**RE: Southeast County Landfill - DEP September 27, 1994 Correspondence Regarding  
September 16, 1994 Site Inspection**

**Subject: Response to the Florida Department of Environmental Protection dated September 27, 1994, Southeast County Landfill, Hillsborough County, Florida, Permit No. S029-158504 and No. SC29-199393.**

**Subject: Definition of Sump Area, Southeast County Landfill, Hillsborough County, Florida, Permit No. S029-158504**

Figure 1. Existing Temporary Sump in Phase VI.

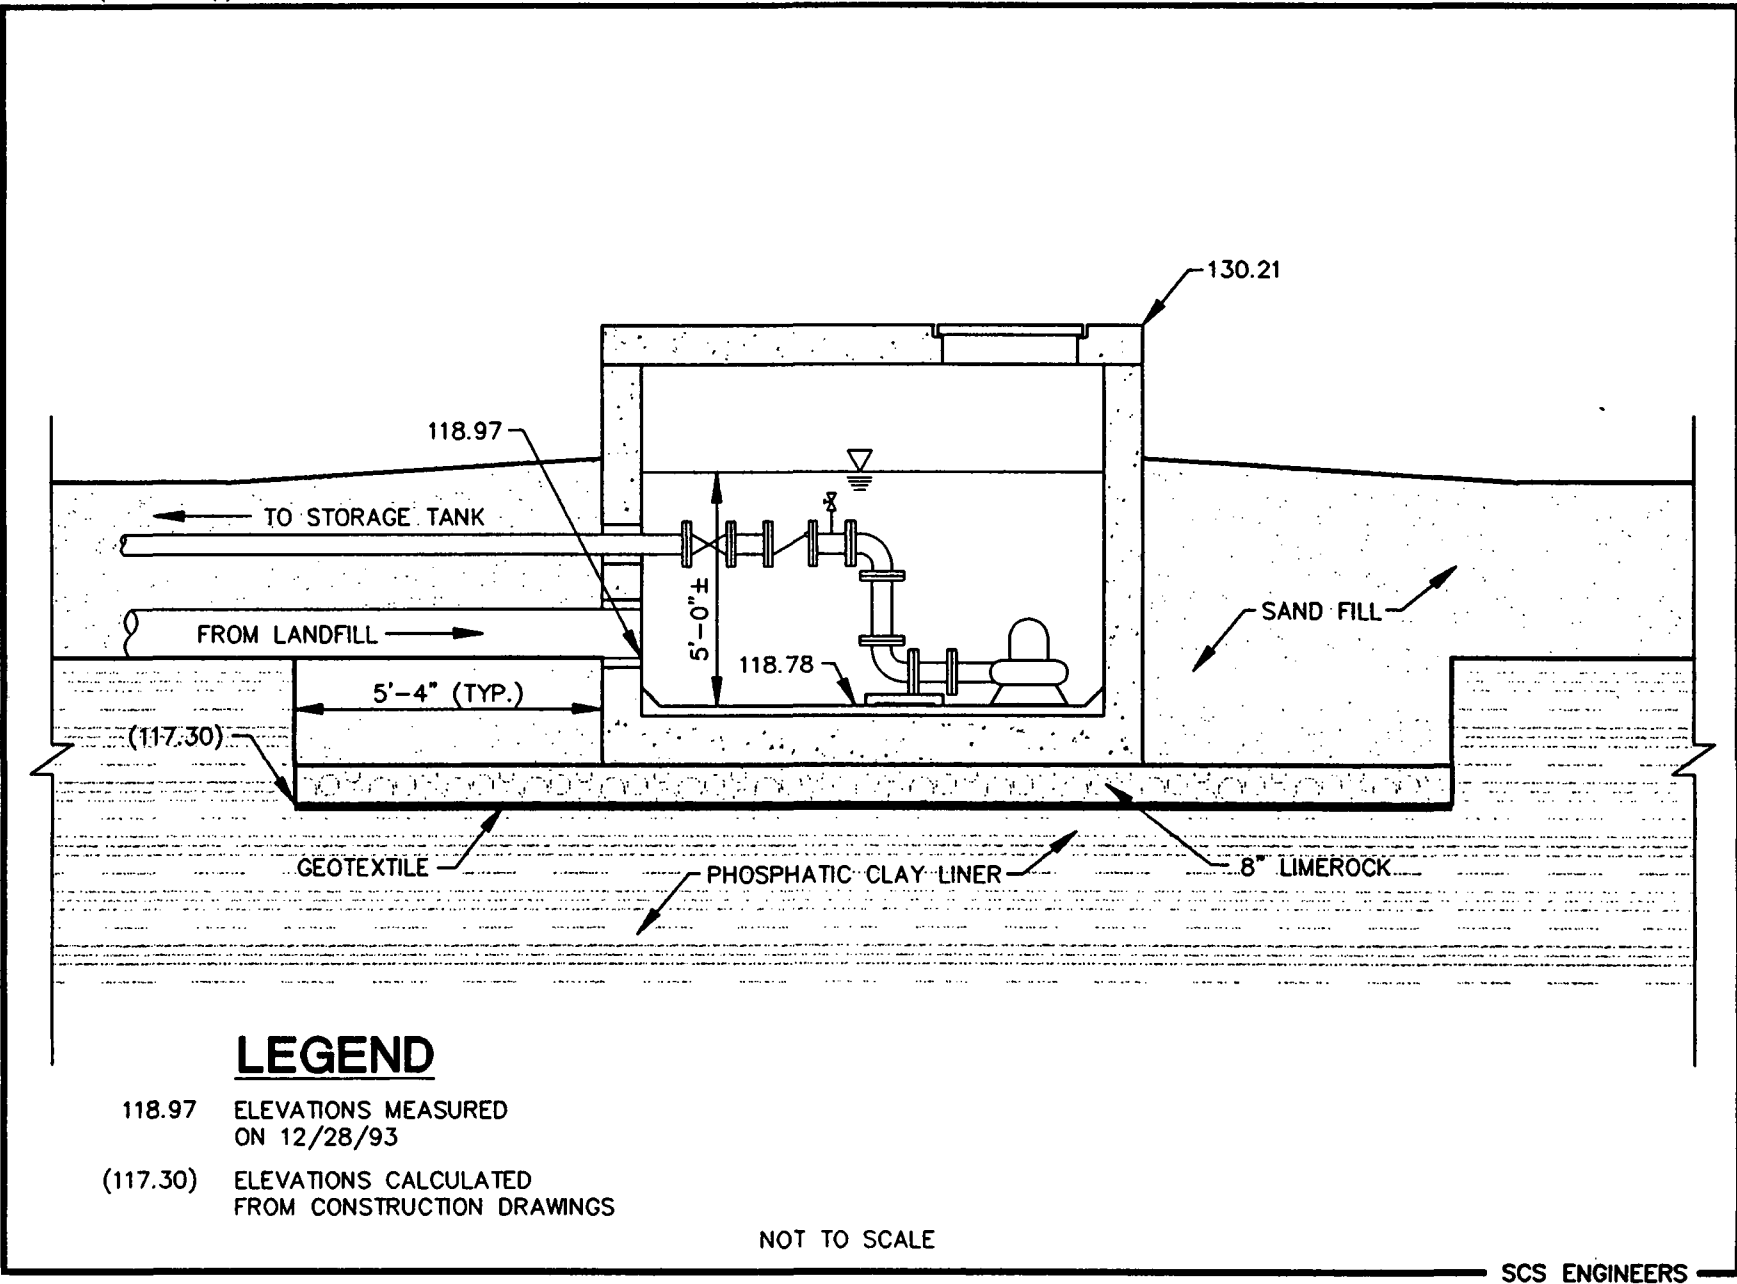
**FDEP Statement 1** - Inspection of the leachate collection sump and leachate stand pipes in both Phase III and Phase IV revealed that approximately 5 to 6 feet of leachate was maintained over the liner in those Phases. Specific Condition #12 of your existing operation permit requires that no greater than 1 foot of leachate be maintained over the liner. In your pending permit renewal application, you are attempting to demonstrate that a level of 3.6 feet of leachate can be maintained over the liner. The levels found during the inspection exceeds both values.

In December 1993, the Hillsborough County Department of Solid Waste (HCDSW) requested that SCS evaluate the leachate levels at the SELF. A survey of the leachate levels and a review of the as-built sump configuration was conducted (see Figure 1). At the time of the survey, the leachate levels were approximately 5 feet above the bottom of the existing temporary leachate sump in Phase VI, which collects leachate from Phases I, II, III and IV. In a letter to the Florida Department of Environmental Protection (FDEP) dated March 11, 1994, SCS presented the leachate level data and concluded that some areas of the landfill had leachate levels in excess of the maximum 12-inch depth specified in Chapter 17-701.400(3)(b), FAC.

**Response** - On March 16, 1994 the HCDSW notified the FDEP of this condition. The HCDSW, FDEP, Environmental Protection Commission (EPC), and SCS have met on several occasions to discuss this issue. As requested by the FDEP, SCS submitted water balance calculations on June 10, 1994 to Kim Ford. In our meeting on May 12, 1994, with Mr. Kim Ford from FDEP and Mr. Paul Schipfer from EPC, the FDEP and EPC suggested that HCDSW redefine the landfill sump. In correspondence to the Hillsborough County Department of Solid Waste (HCDSW) dated June 24, 1994 (Attachment 1) and in the pending permit renewal application, SCS provided sufficient information to define the entire landfill footprint as the sump for the SELF (excluding the sidewalls of the perimeter berms with synthetic liner) and establishing a target maximum leachate level over the liner of 3.6 feet. Additional information currently is being prepared by SCS on this issue to be submitted to Kim Ford as part of the permit renewal request for information responses.

Figure 7. Pore Pressure Versus Depth Relationship From Piezoprobe Test Results at PP-2.

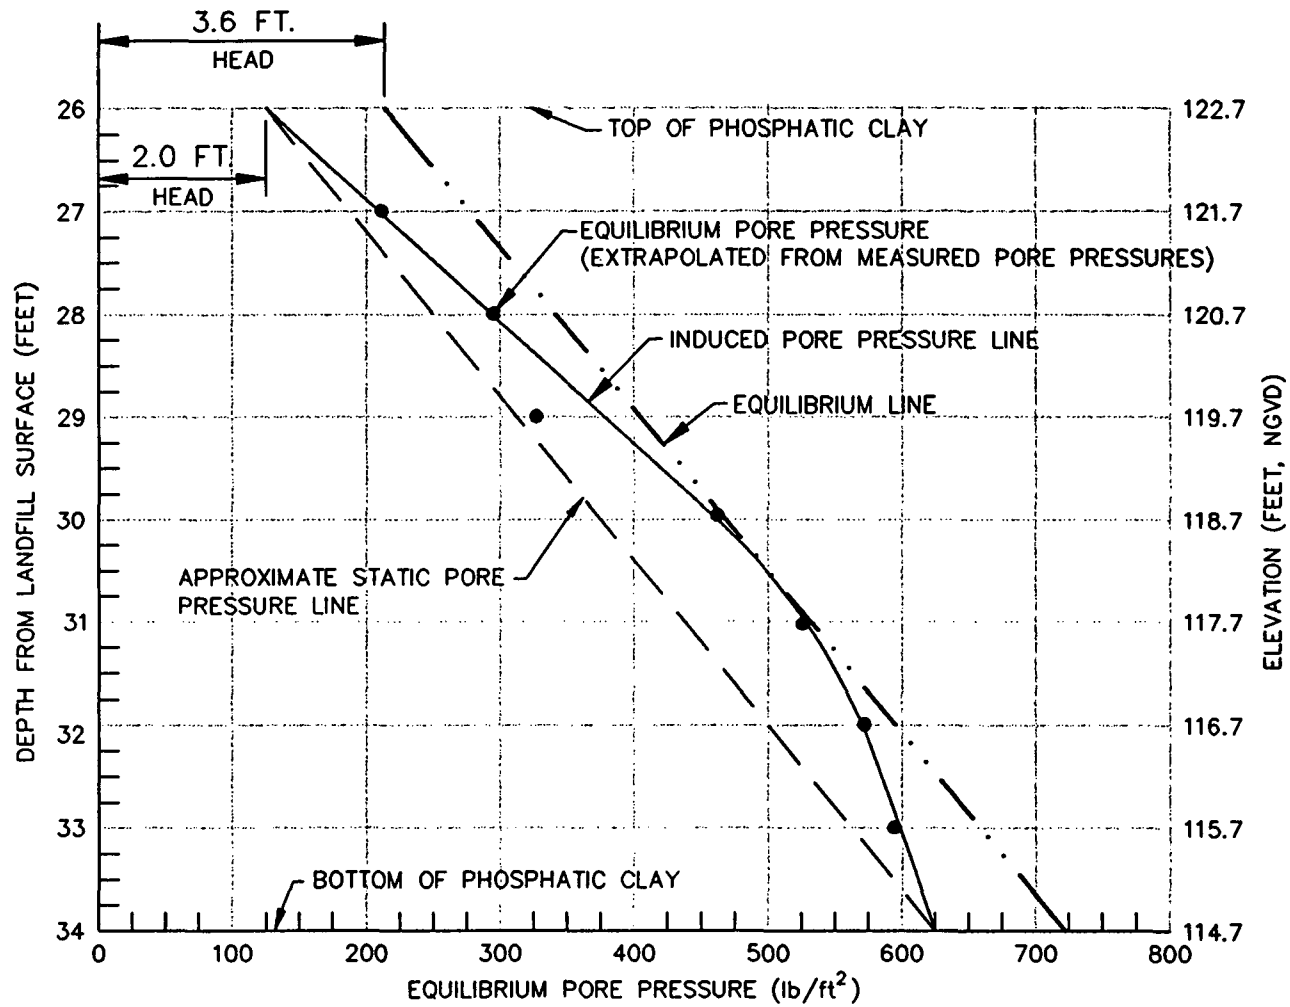
X This concept is illustrated in Figure 7. The figure was adapted from the most recent geotechnical investigation conducted by Ardaman and shows plots of the equilibrium pore pressures extrapolated from measured pore pressures in the field, the approximate static pore pressure line with 2 feet of leachate over the liner, and the equilibrium pressure line where induced pore pressures would be balanced by leachate head. The location of the test piezoprobe PP-2 (Phase 2 area) is representative of the anticipated worst case conditions after the 7-year consolidation period has occurred and most of the pore pressures have dissipated.

Based on the theoretical performance of the waste phosphatic clay deposits and the measured pore pressures in the field, leachate levels in the landfill up to 3.6 feet are acceptable.
